**Topic: Caribou and moose: Movement, habitat, methodology: Risk - characterization of adverse residual effects (DAR Section 4.5.4, Table 10.3)**

**Topic: MVEIRB IR 63 - Caribou and moose: Mitigation and offsetting impacts to caribou habitat (DAR sections 10.4.2.2, 10.8.1)**

**Topic: MVEIRB IR 65 - Wildlife: Effectiveness of Plans and Adaptive management (RB ORS overarching IR 2)**

**Topic: Route alternatives: Alternative means, road alignment proposed by Pehdzéh Kì First Nation (DAR section 5.2.3, table 5.2, section 7.2)**

**Figure 67-1 Overview conditions at Source 10.043 - A) Facing North; B) Exposed sand and gravel material within the existing pit**

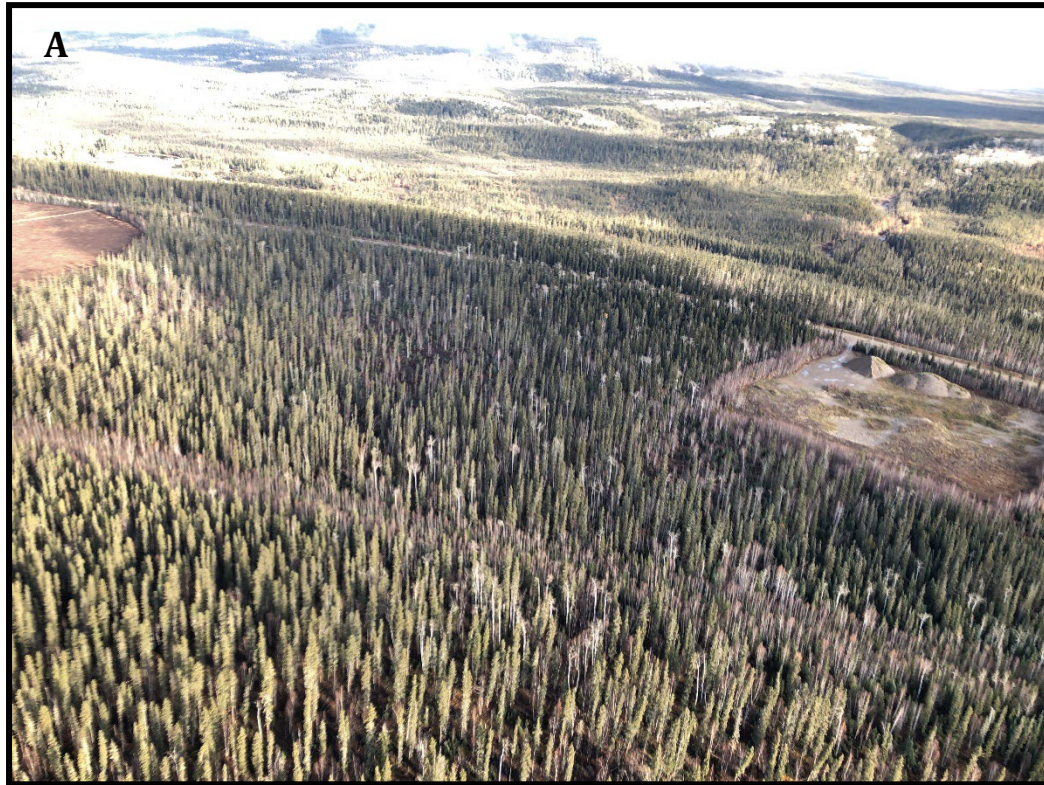
- drone footage or video from a helicopter of the entire route during the summer open water season.
- summer ground-level photos at intervals where there is a change in topography or ground conditions to complement the plan view map book in Appendix 5A
- ground-level and airborne photos of proposed quarry sites.

- Proposed borrow and quarry sources, per Table 5.4 of the DAR, except for Edie Lake Quarry, which is an existing GNWT quarry (see Figures 67-1 to 67-14). The location of these sources is shown in Figure 1.2.1 (Overview), and Appendix 5A (Project Mapbook) of the DAR.
- Representative photos of common dominant surficial material encountered in the RSA (see Table 67-1)
